## Woodward-Clyde Consultants

### REVISED FINAL RI REPORT

**ITEMIZED RESPONSE TO NYSDEC COMMENTS  
REYNOLDS METALS COMPANY  
MASSENA, NEW YORK**

**REVISED  
FINAL REMEDIAL INVESTIGATION REPORT  
ST. LAWRENCE REDUCTION PLANT**

FIGURE 16

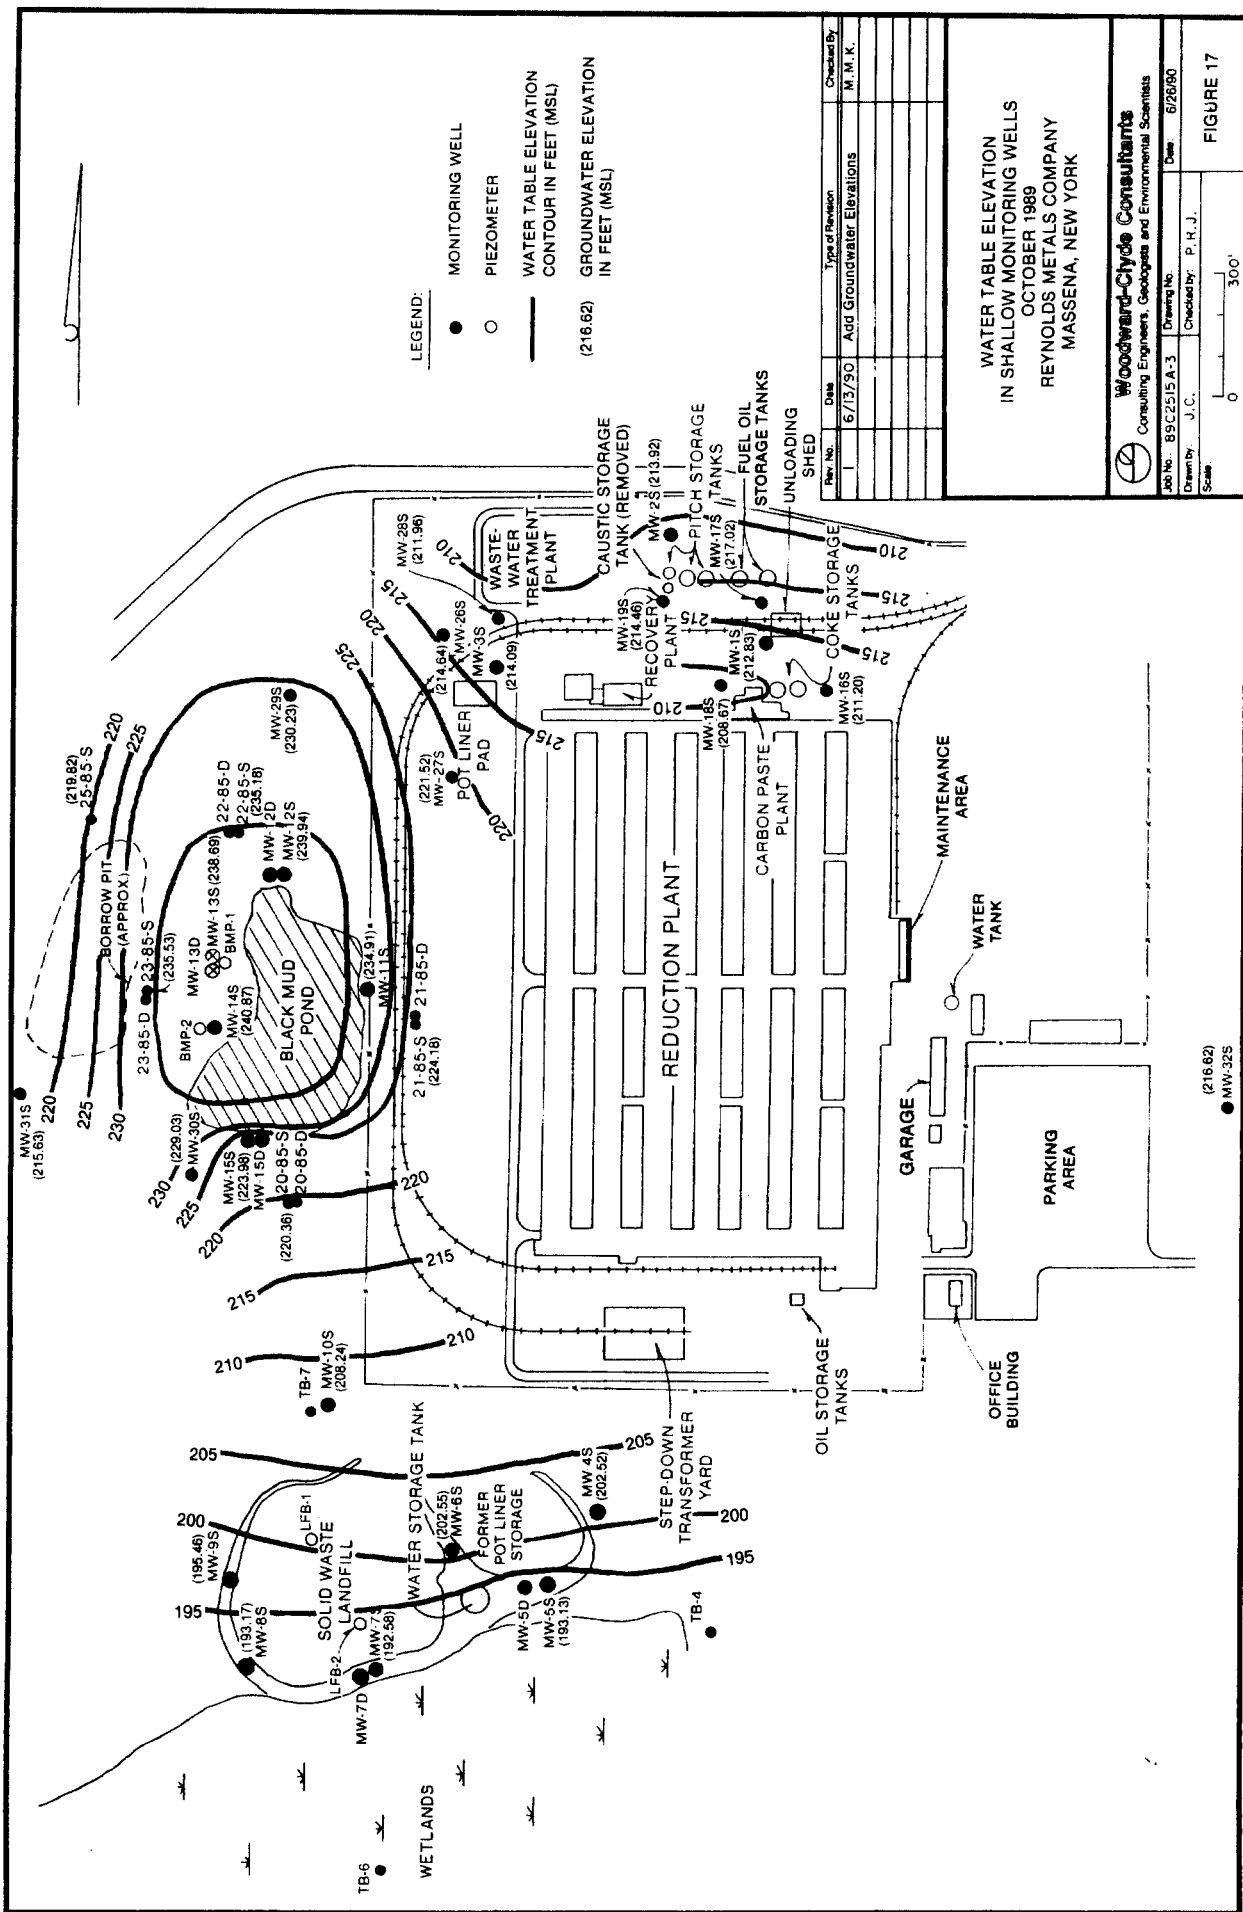
**Figures 16 and 17**

Figures 16 and 17 have been updated to indicate measured groundwater level elevations from October 1989.
